GULMOHAR RESIDENCY

Details of Additions & Alterations

Flat No	302	Block no.	' D '
Flat Area	1660 sft	Type	Deluxe / Luxury ✓
Buyer Name	V. PAUL DEVADATHAM		
Phone No.	9441853235	Email	VPAUL_124@rediffmail.com

Description	Direction	Owners & Developers :	Date :	Promoted by :
PLUMBING PLAN-1660 Sft (B2-TYPE)	N	Modi Reality Mallapur LLP	04.09.20	Modi Properties Pvt Ltd
		Project Name & Phase :	Prepared By :	
		Gulmohar Residency	Approved By :	
			Scale :	
			N.T.S	Phone: +91-40-66335551

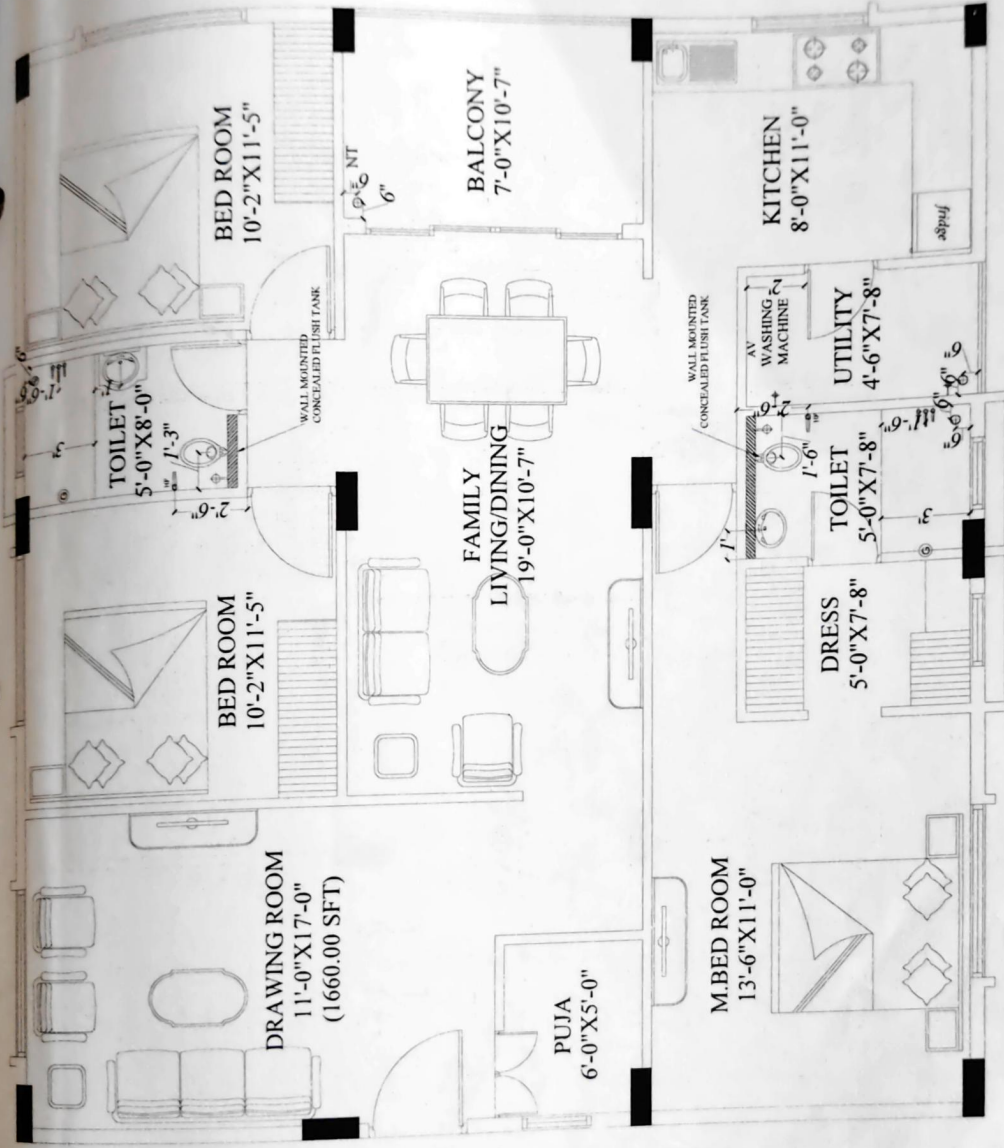
C-T → ~~SPRINK~~ Lunar.

M-T → Malayram

utility → Defint as

kitchen fan → Defint as same.

① Balcony & kitchen - flung same

Description	Direction	Owners & Developers :	Date :	Promoted by
WORKING PLAN-1660 SR - B2 TYPE	N	Modi Reality Mallapur LLP Project Name & Phase : Gulmohar Residency	25.09.2020 Prepared By : Jayaprada Sobham Modi Approved By : N T S Scale :	Modi Properties Pvt Ltd Phone +91-40-66335551

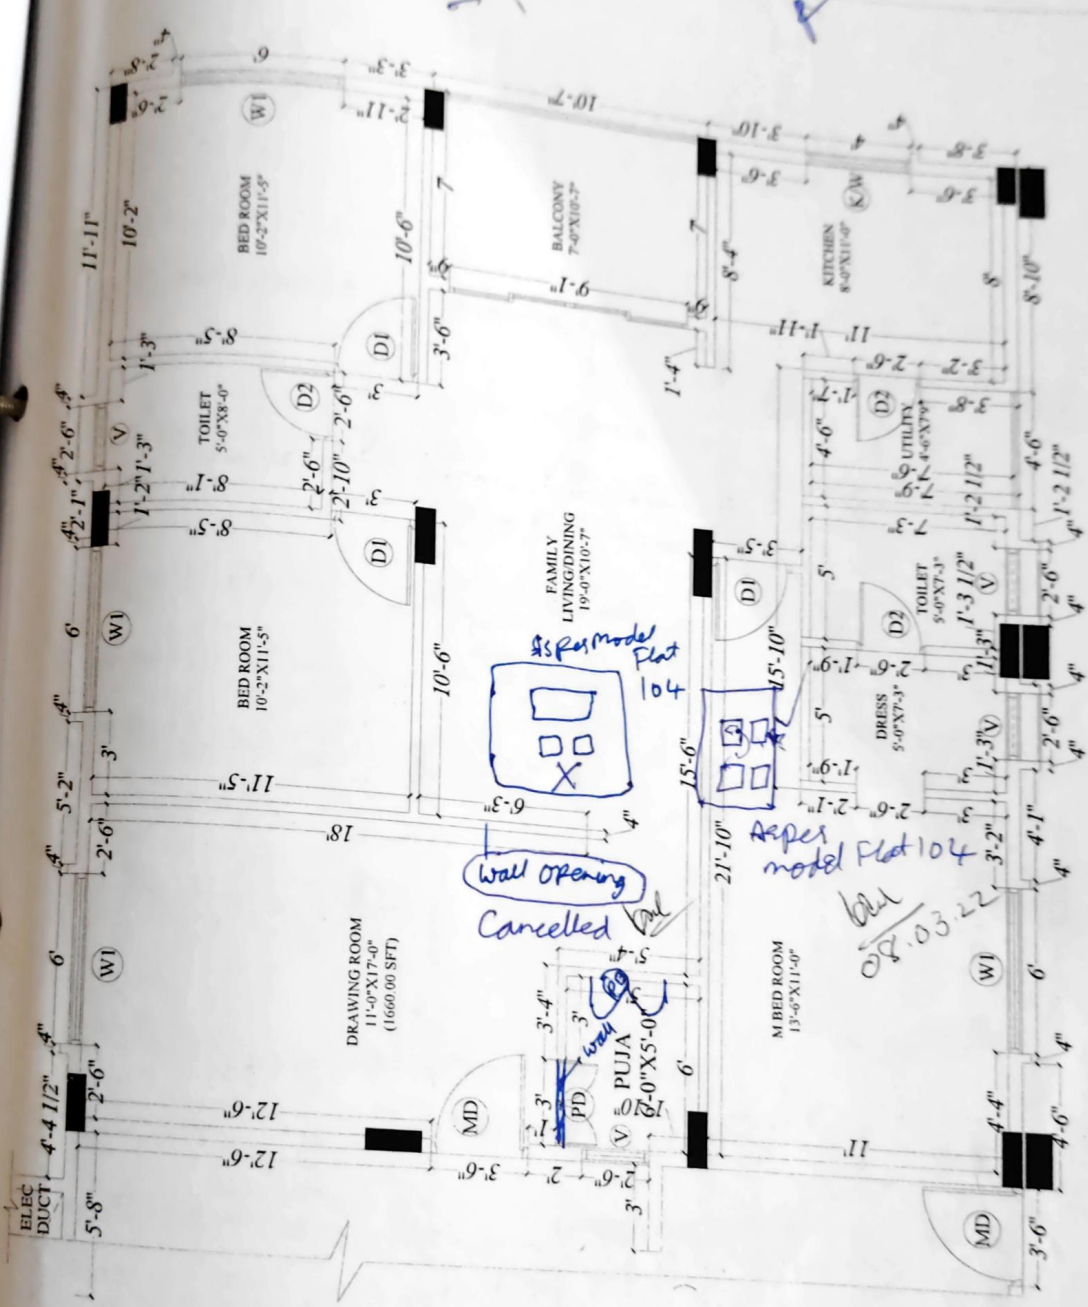
1) Pooza Room Door changing as per Drawing.

As per model Flat 104

As per model Flat 104
